46410 fremont boulevard
fremont, ca 94538 usa
925.583.8400
bridgelux.com

RE: Engineering Change Notification for: Gen 7/8 Vero SE

Ref: BL-ECN-03092023

After /Before change (Ref. Vero 13SE)

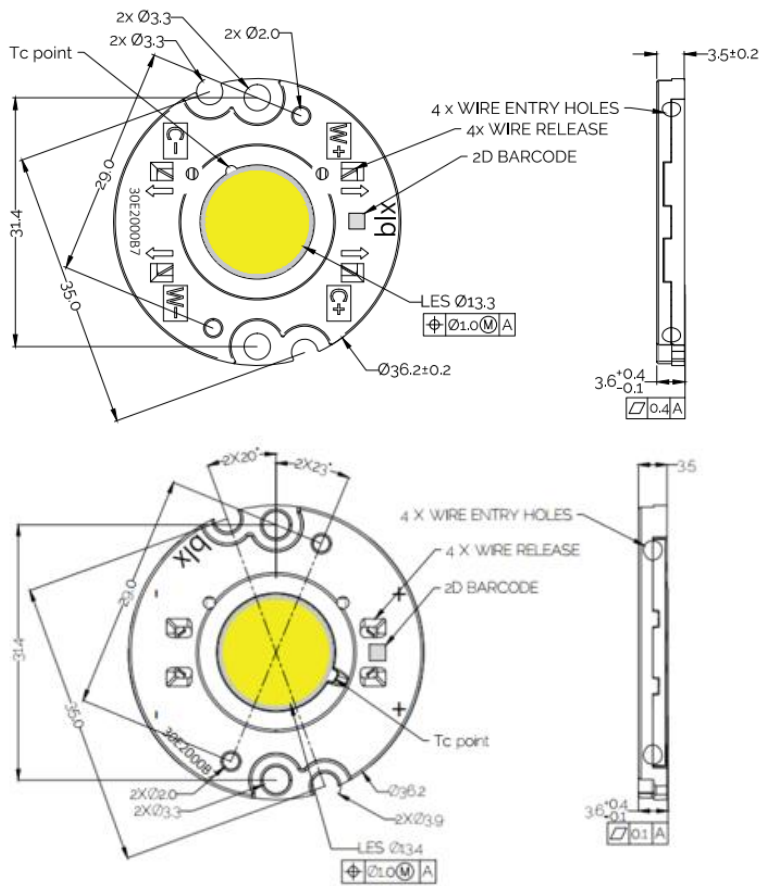
The COB arrays in the Vero SE series products remain the same, but the holders will have a new modified design based on the current design. Please contact your Bridgelux representative if you need samples of the Vero SE with new holders.
